# **CAMPSIE MASTERPLAN PLANNING PROPOSAL**

## **Responses to the department's urban design questions**

## 1. Campsie Masterplan 3D modelling - General View

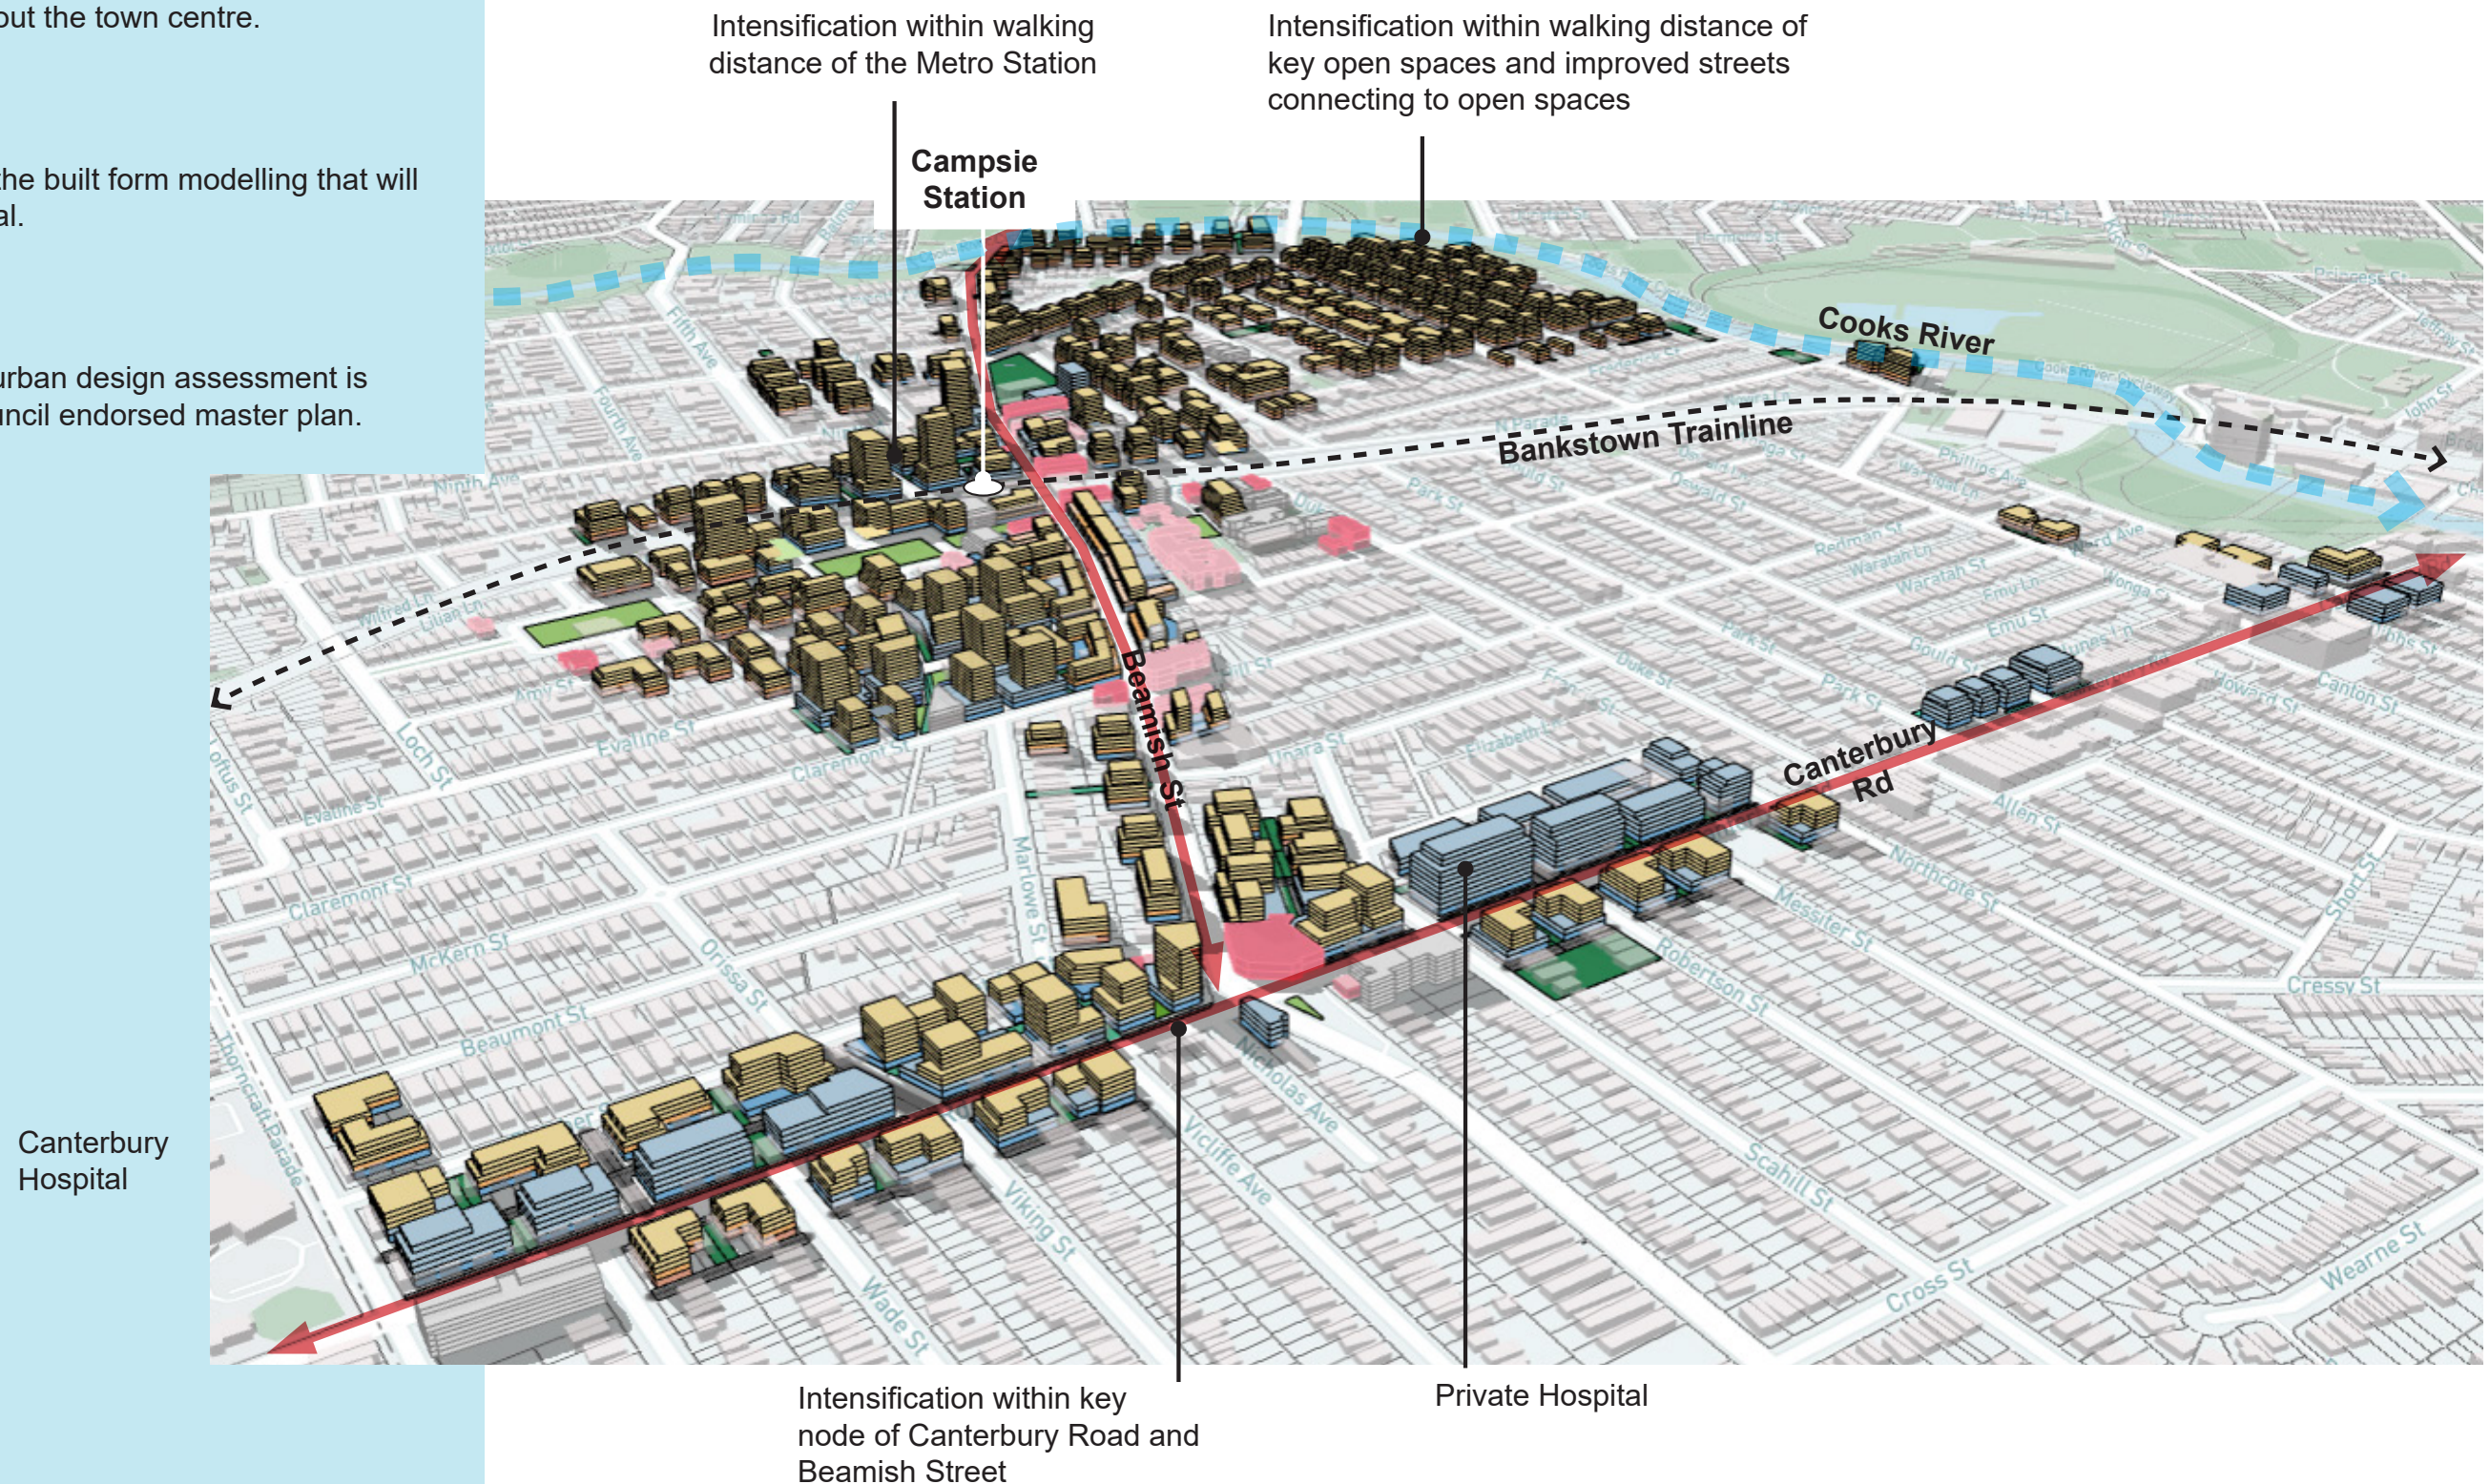
Provide clearer drawings and images to better illustrate the comprehensive proposed built form changes for the full city centre, such as three dimensional drawings that can demonstrate the built form changes throughout the town centre.

Clearly demonstrates the built form modelling that will result from the proposal.

Demonstrate that the urban design assessment is consistent with the council endorsed master plan.

This part addresses questions 1, 2, and 3, supported by evidence from the 3D model to illustrate built form changes that is consistent with the endorsed master plan.

## 3. Campsie Masterplan 3D modelling - Base Controls VS Masterplan Control

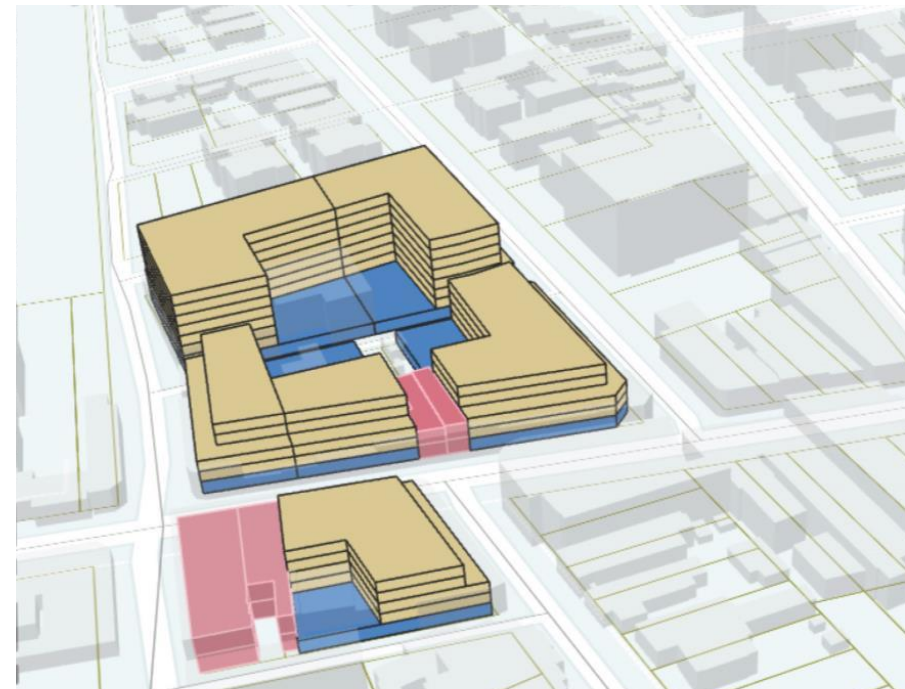
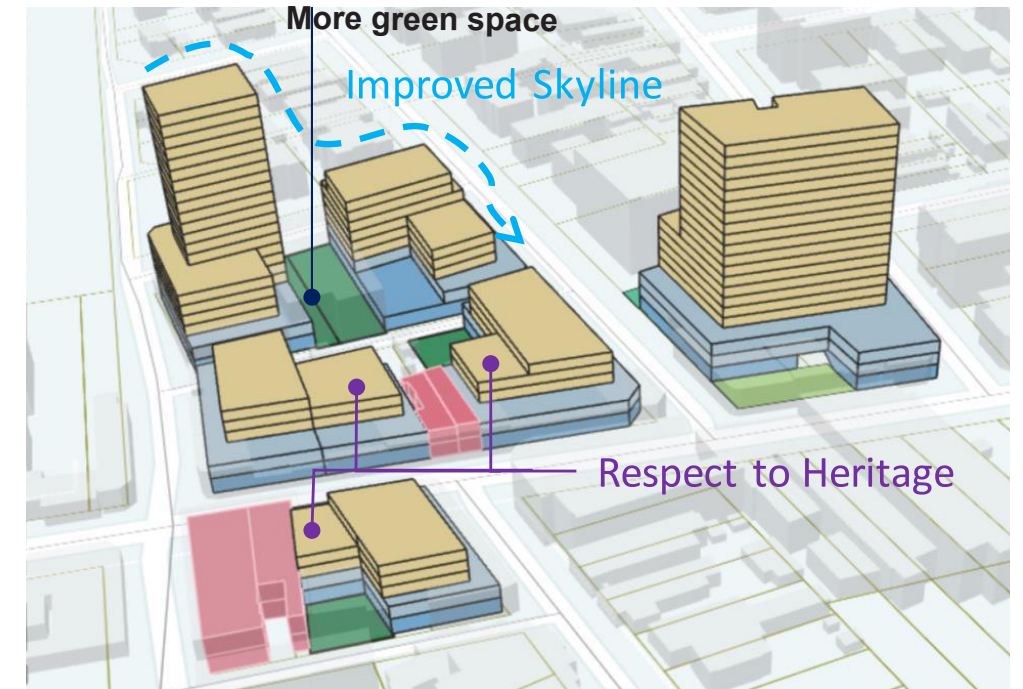
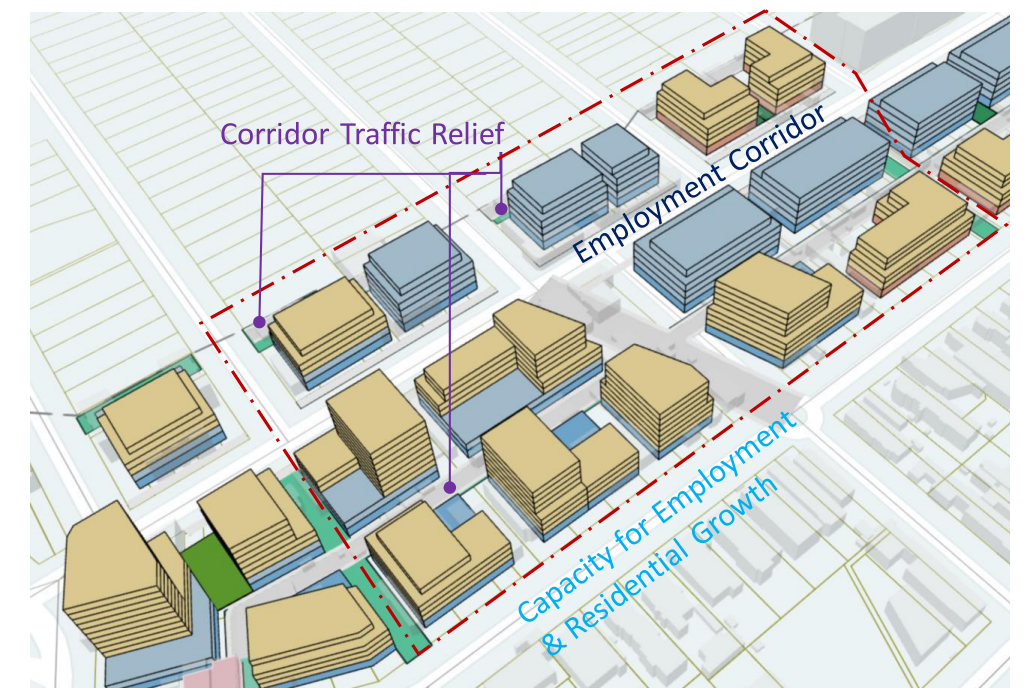
Provide clearer drawings and images to better illustrate the comprehensive proposed built form changes for the full city centre, such as three dimensional drawings that can demonstrate the built form changes throughout the town centre.

Clearly demonstrates the built form modelling that will result from the proposal.

Demonstrate that the urban design assessment is consistent with the council endorsed master plan.

The Campsie Masterplan provides additional density compared to the base controls, ensures development is sympathetic to character and heritage, creates interesting skyline, and provides additional public benefit by increasing green space provision for example.

The Campsie Masterplan provides additional capacity for employment compared to the base controls, and provides additional public benefit such as corridor traffic relief and service laneway at the back of the busy canterbury Rd corridor.

### Site 1 - Cooks River Edge

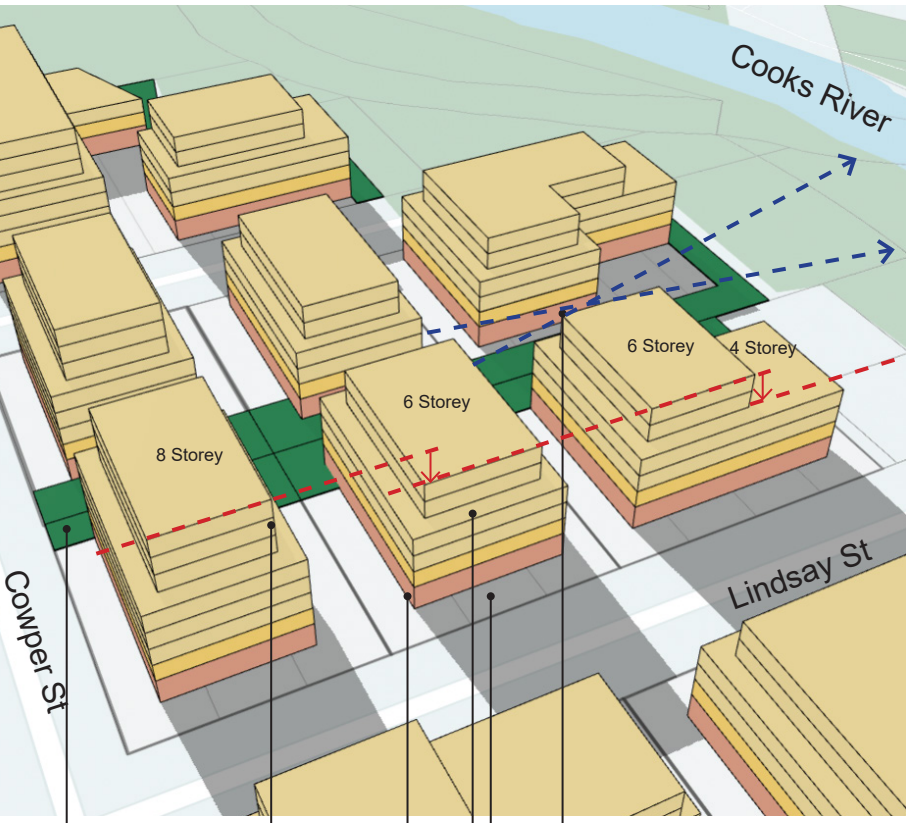
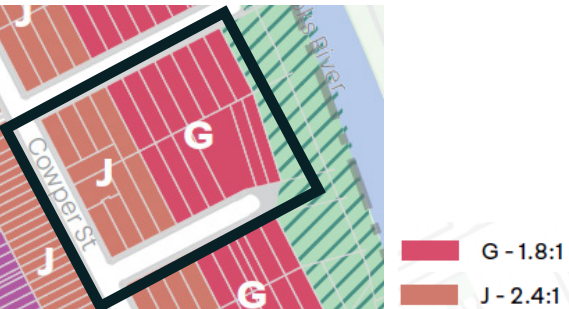
Provide further information regarding the built form testing undertaken to clearly demonstrate the appropriateness of the proposed controls with particular focus on SEPP 65 and ADG analysis.

Provide further information to demonstrate that the proposed FSR and heights can be realised.

Concern is raised that some sites do not take into account future retail and commercial podiums so a particular focus is to be made to the proposed amendments seeking to deliver tower built-form outcomes.

Site 1:	Site 2:	Site 3:
Site area: 1,670	Site area: 1,670	Site area: 2,230
Total GFA: 4,030	Total GFA: 3,380	Total GFA: 3,960
FSR: 2.4	FSR: 2.0	FSR: 1.8
Street setback: 6m	Street setback: 6m	Street setback: 6m
Upper level setback: 3m	Upper level setback: 3m	Upper level setback: 3m
St wall height: 5	St wall height: 4	St wall height: 4
Height in storeys: 8	Height in storeys: 6 (note: site across two different FSR controls: 2.4 and 1.8. )	Height in storeys: 6

- Consolidated deep soil strip across property boundaries
- Street wall height and building height stepping down towards the Cook River
- Residential Ground floor: 4.4m F.t.F.
- Residential first floor and above: 3.1m F.t.F.
- Increased rear boundary setback to open views to the river to neighboring
- 6m street setback for increased amenity and privacy as well as preservation of existing streetscape character
- 3m Upper level setback

### Site 2 - North Station

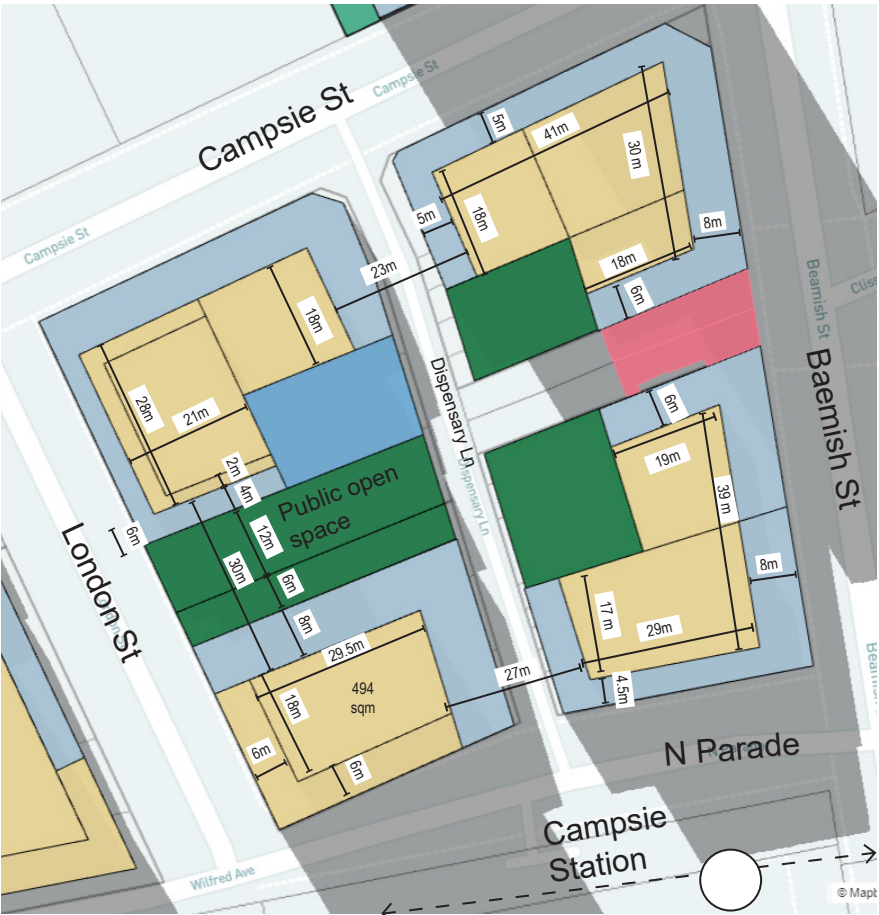
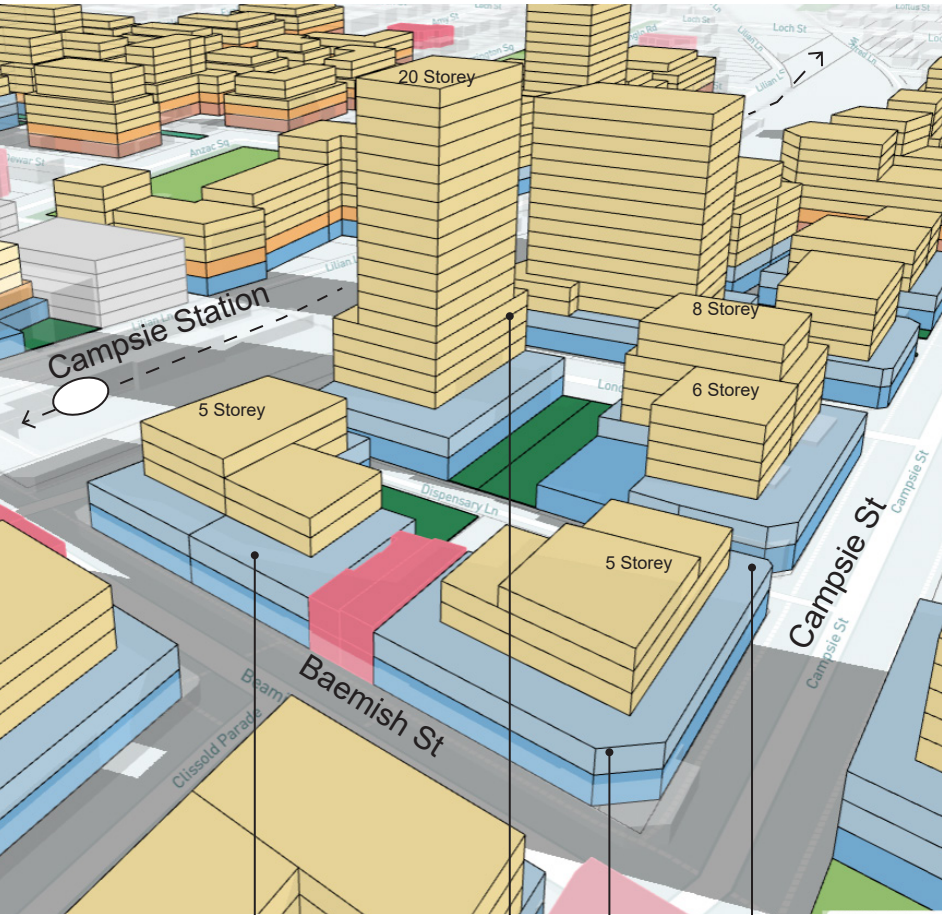
Provide further information regarding the built form testing undertaken to clearly demonstrate the appropriateness of the proposed controls with particular focus on SEPP 65 and ADG analysis.

Provide further information to demonstrate that the proposed FSR and heights can be realised.

Concern is raised that some sites do not take into account future retail and commercial podiums so a particular focus is to be made to the proposed amendments seeking to deliver tower built-form outcomes.

Site area: 2,685 sqm  
GFA: 6,450 sqm  
FSR: 2.4:1  
Street setback: 1m to Dispensary Ln  
Upper level setback: 7.5m  
St wall height: 2  
Height in storeys: 8

2 Storey commercial podium and increased upper storey setback to integrate heritage building and retain existing street scale and character.

20 storey slender tower delivers increased density next to public transport node with reduced overshadowing impact.

2 storey street wall with generous setback delivers increased amenity and extend the human scale of Baemish St along Campsie St.

Commercial ground floors and first floor deliver employment and services in the center of Campsie anchoring it function as a major center for the area.

### Site 3 - Campsie RSL

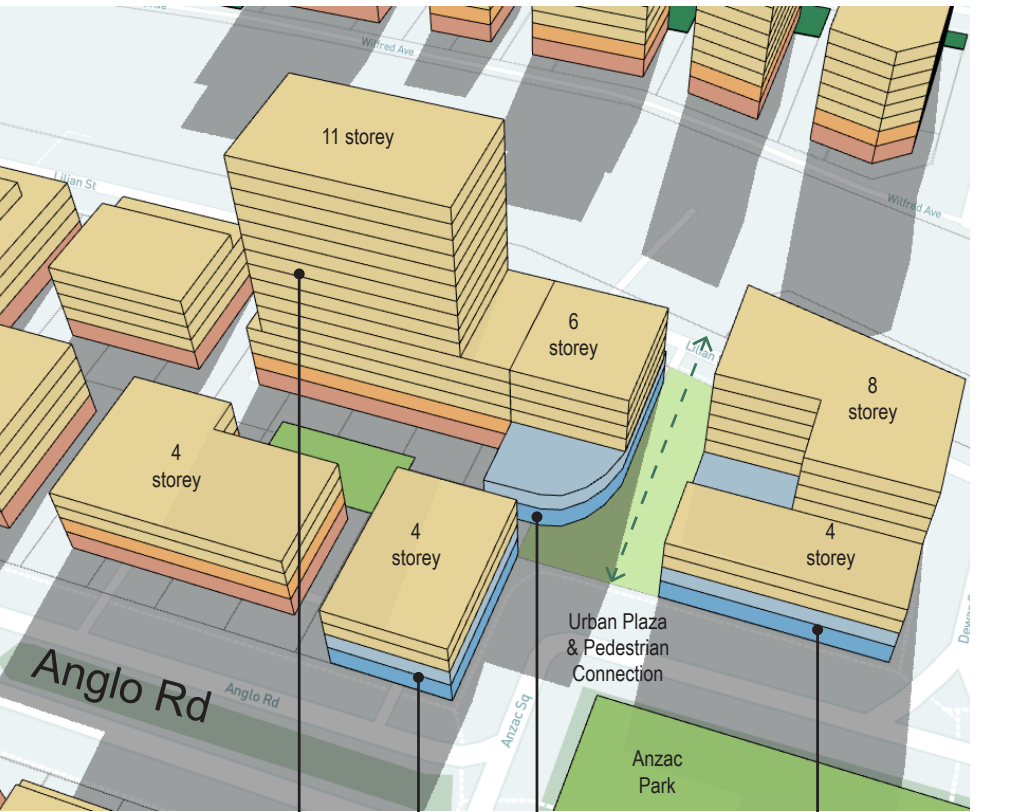
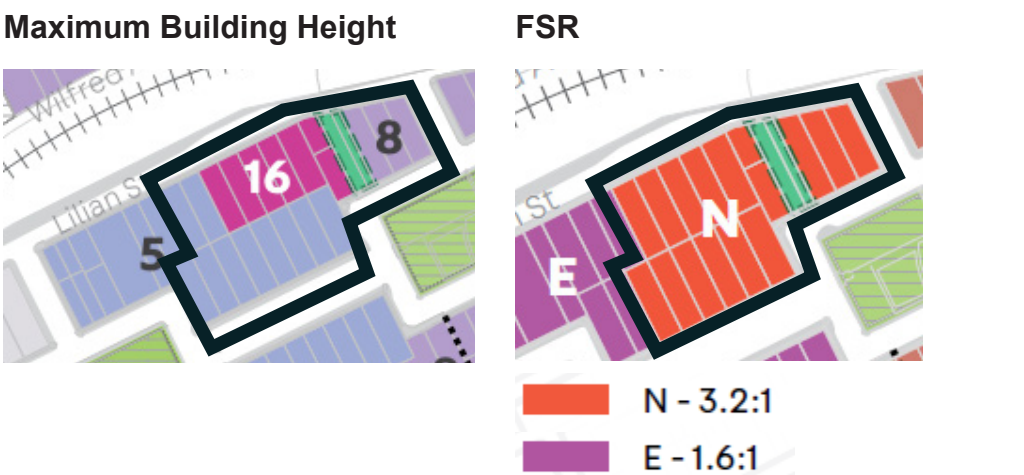
Provide further information to clearly demonstrate the appropriateness of proposed densities and heights to ensure an appropriate level of solar access is provided to:

- i. public open space in mid-winter; and
- ii. neighbouring sites and compliance with SEPP 65 and ADG requirements.

Site area: 8,020 sqm  
Total GFA: 25,661 sqm  
FSR: 3.2 above ground  
1:1 underground (not represented on the model)  
Height in storeys: 2 - 11 storeys  
Infrastructure: Urban Plaza and Pedestrian connection

Building separation compliant with ADG requirements

Reduced tower floorplate above 8 storey to comply with tall Building study recommendations
